# HIT Hand Riveter Update

## HR 005 → HR 005 CG

### Appearance :

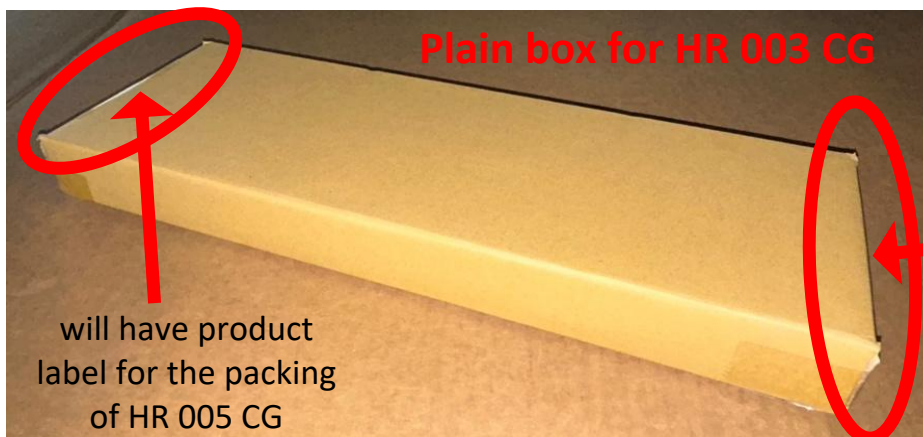
•HR 005

Length:310mm

650mm (full opened)

Weight:1.5kg

Capacity:3.2 / 4.0 / 4.8

•HR 005 CG

Length:320mm

790mm (full opened)

Weight:2.0kg

Capacity:3.2 / 4.0 / 4.8 / 6.4

•Packing

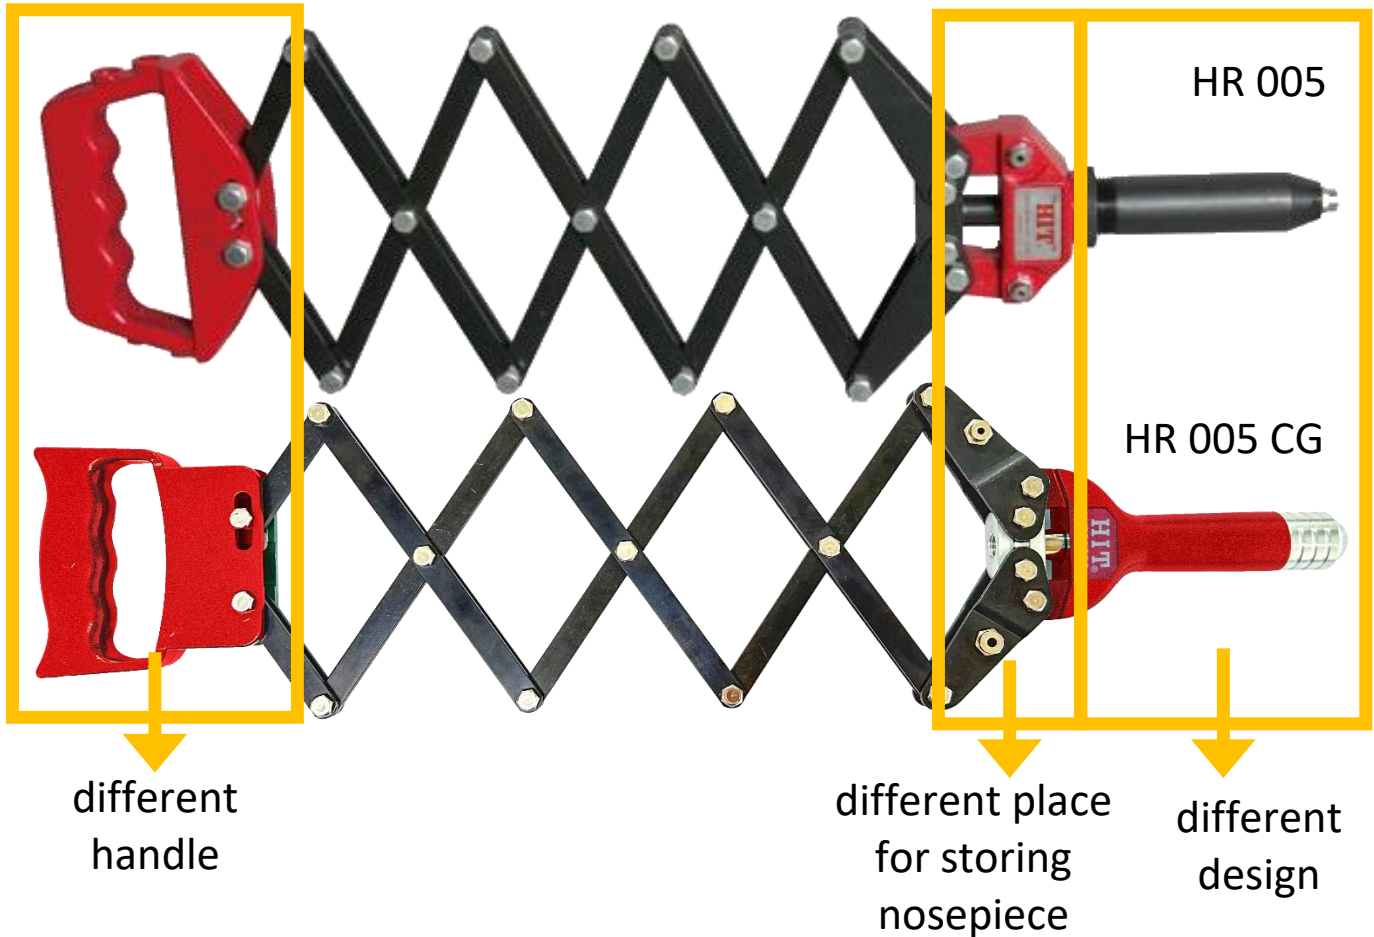
Current packing for HR 005:Printed box for the riveter

New packing for HR 005 CG:

Plain box without print, with item label pasted on side.

\*Which looks similar to the packing for HIT HR 003 CG.

For the new packing of HR 005 CG, product label for HR 005 CG will be pasted on both side of the box, like the red circle in the above.

And the layout of product label for HR 005 CG will be similar to the one for HR 003 CG.

•Product difference

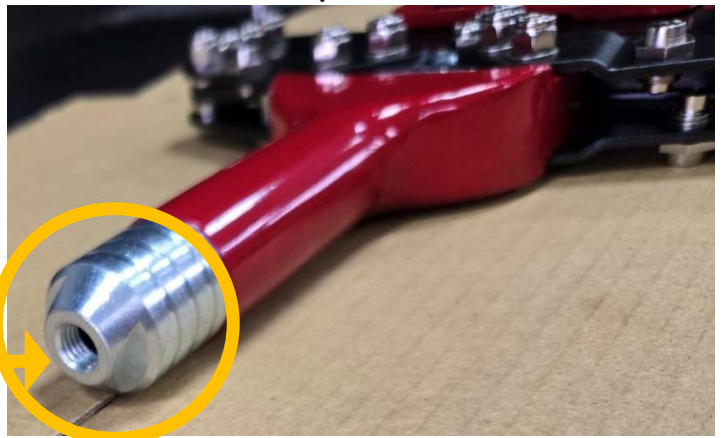
About nosepiece:  
HR 005 CG has 4 different nosepieces, which is more than HR 005.

Its default state is "having no nosepiece on the top".

The place for storing nosepieces is on the front link frame of HR 005 CG, which is different from HR 005.

Please take the nosepiece from the front link frame and install it.  
(Nosepieces will have number carved that shows its capacity)
